CITY PLANNING COMMISSION

- APPLICATION:**
1. Negative Declaration
 2. Special Permit to exceed the 25 percent office use to allow the development of a 40,180 sq. ft. office building on 1.6+ vacant acres in the Heavy Industrial (M-2(S)) zone

LOCATION: Southeast corner of Kiefer Boulevard and Florin-Perkins Road

P89-275

EXHIBIT A SITE PLAN

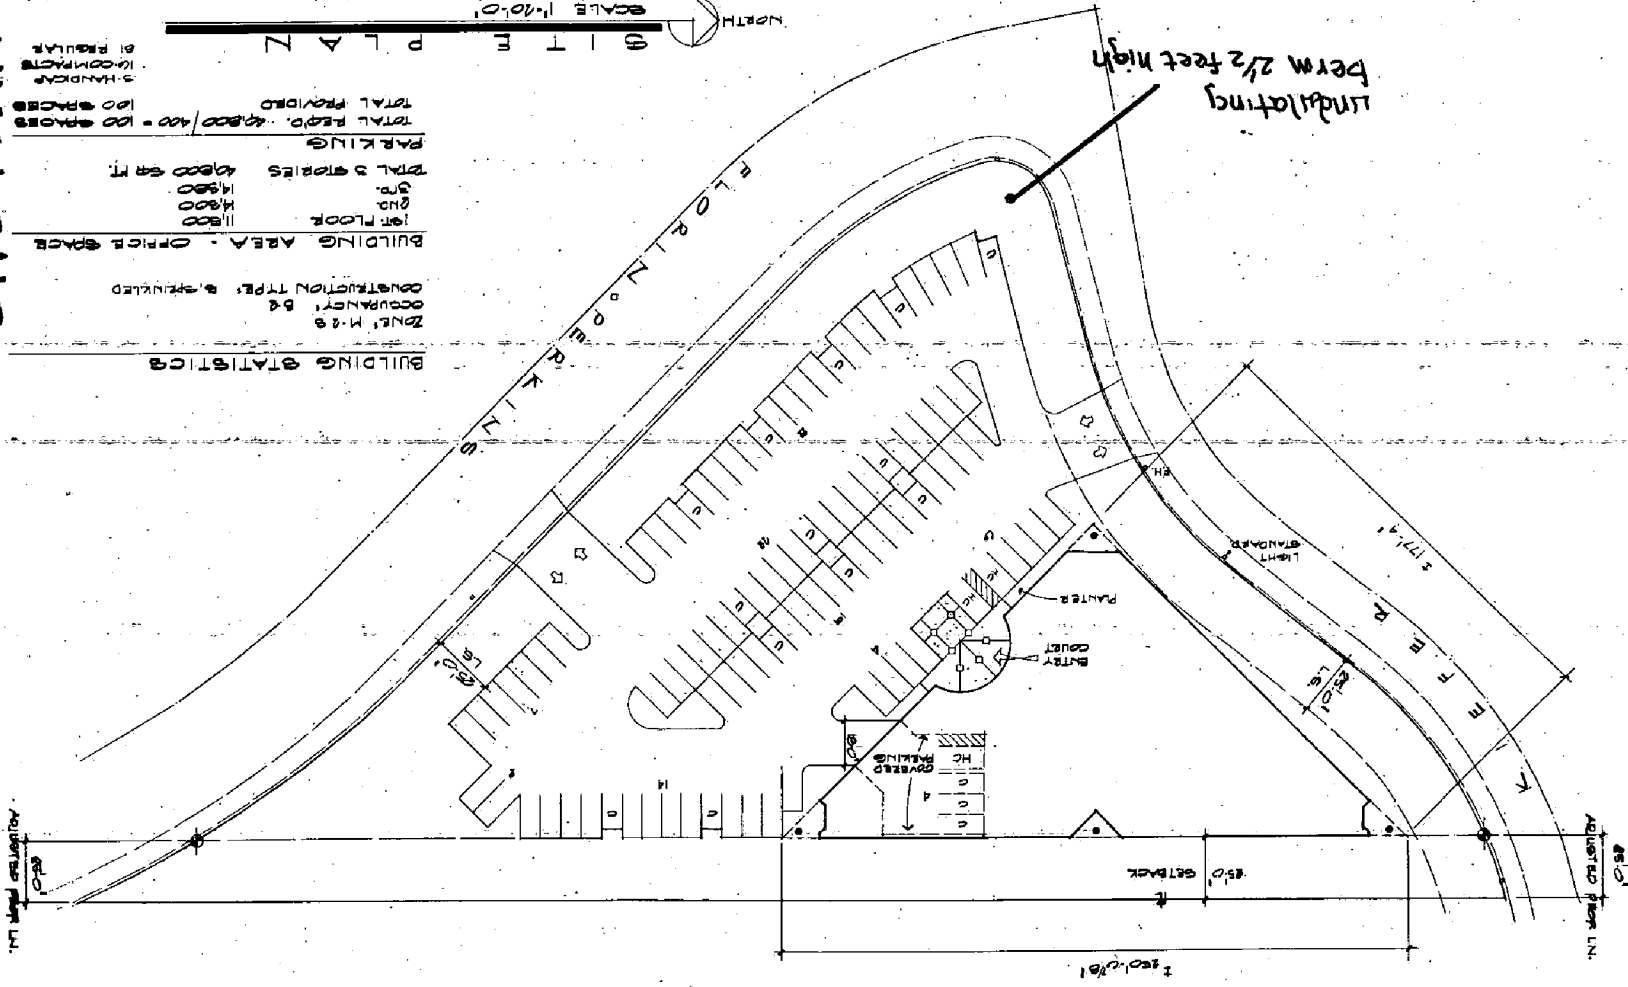
The submitted site plan indicates a driveway entrance off of both Florin-Perkins and Keifer Boulevard. A 25 foot landscape setback between the parking areas and the front yard and street side yard property lines is indicated. A 25 foot interior side yard is shown on the site plan between the building and some of the parking area.

A landscape plan has been submitted. The submitted plan indicates fifteen, five and one gallon trees within the setback areas. Ground cover consisting of scotch moss, blue grass and lawn grass is proposed. The site plan indicates two foot high undulating berms along the 25 foot setback fronting on Florin-Perkins Road and Keifer Boulevard. Staff recommends that the 25 foot setback area contain 3-1/2 foot high undulating berms. The corner berm, where Keifer Boulevard and Florin-Perkins Road intersect, can be 2-1/2 feet high to allow vehicle clearance (see exhibit A). The berms shall be overlapping. Ground cover and trees are proposed in the 25 foot interior side yard setback area. Fencing proposed for the site shall be indicated on the site plan identifying material and height and shall be reviewed by staff prior to issuance of building permits.

The trash enclosure indicated on the site plan is located inside of the building on the first floor. Trash dumpsters located outside of the structure will be required to meet the Zoning Ordinance regulations for trash enclosures.

No signage is indicated on the site plan. The subject site shall be allowed one attached sign per street frontage and one monument sign. The monument sign shall not exceed 6 feet in height. Signage proposed on the subject site shall be reviewed and approved by the Planning Director prior to issuance of sign permits. All satellite and mechanical equipment shall be attractively screened. Final design and material shall be reviewed by staff.

The submitted site plan indicates a total of one hundred (100) parking spaces. One hundred (100) spaces are required for the proposed office use. Staff finds that sufficient parking will be provided on the subject site. The site plan indicates three handicap spaces, sixteen compact spaces (3 covered) and eighty-one standard parking spaces. Seven bicycle locker facilities are proposed on the subject site. Implementation of a Transportation Management Plan (TMP) will be required prior to issuance of building permits. Trip reduction measures such as transit passes, carpool/vanpool and showers and lockers on the site may be required. Processing time for approval of a TMP may take up to 60 days. Therefore it is advisable that the applicant obtain the necessary TSM processing application in advance of the building permit.

As previously noted, one driveway entrance and exit is off of both Keifer Boulevard and Florin-Perkins Road. The City's Traffic Engineer indicated to staff that there were no problems with the circulation pattern proposed on the site plan. It is recommended that a 2 foot vehicle overhang be provided for vehicle parking. The parking lot area will be required to meet the 50 percent shading requirement.

1. The 25 foot setback areas between the parking and the front yard and street side yard property lines shall be planted with 3-1/2 foot undulating berms. The 3-1/2 foot berms shall be overlapping.

2. Trash dumpsters located outside of the building shall be required to meet the Zoning Ordinance requirements for trash enclosures.
3. Fencing proposed on the property shall be indicated on the site plan and subject to review and approval by planning staff prior to issuance of building permits.

4. A 2 foot vehicle overhang shall be provided for vehicle parking.
5. Any signage proposed on the subject site shall be reviewed and approved by the Planning Director prior to issuance of sign permits. One attached sign per street frontage and one monument sign not exceeding six feet in height shall be allowed.

6. Pedestrian access from the LRT station to the building's entrances shall be as direct as possible. In the parking lots, this access shall be protected from automobile traffic for safe pedestrian routes.

9. The parking area shall be required to meet the 50 percent shading requirement.
10. Reveal lines shall be wide and deep to present a well defined shadow line.

ELEVATIONS
EXHIBIT B

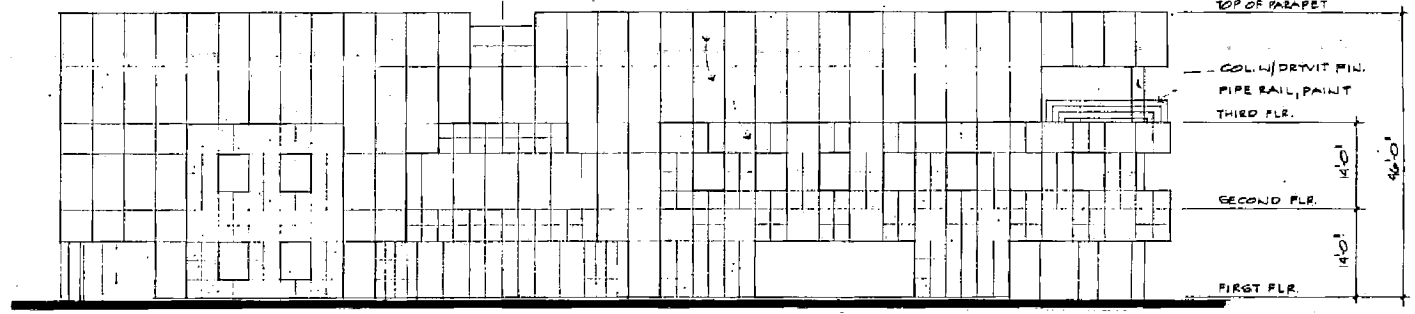
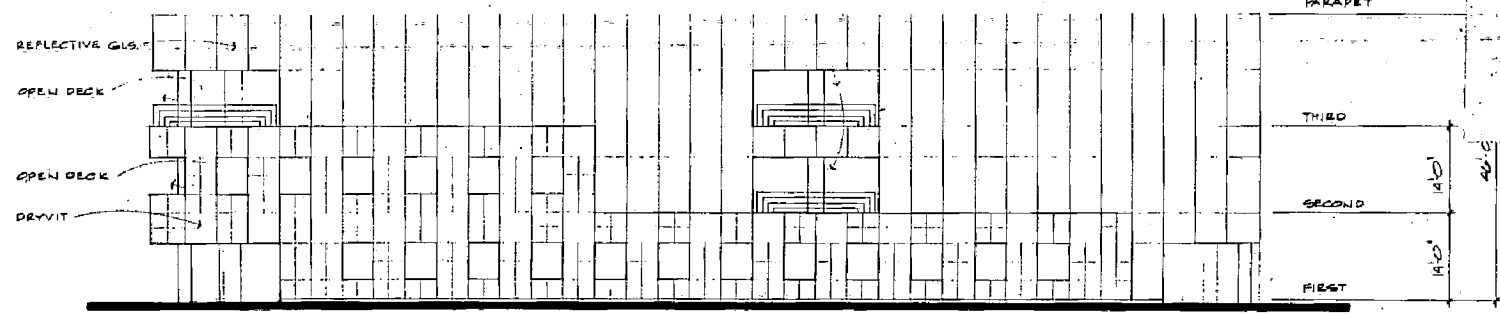
The proposed building design consists of reflective glass and dryvit with a built-up roof. The building height is 46 feet with three floors. Building area on the three floors will be 11,500 square feet, 14,300 square feet, and 14,380 square feet, respectively. Staff supports the overall building design but would prefer a metal circular column natural finish in aluminum to match with the horizontal curtain wall or painted metal to match the color of the railing. The reveal lines should be wide and deep to present a well defined shadow line.

Interior of the parapet wall shall be finished in a manner equal to the exterior surface of the building.

11. The interior of the parapet wall shall be finished in a manner equal to the exterior surface of the building.
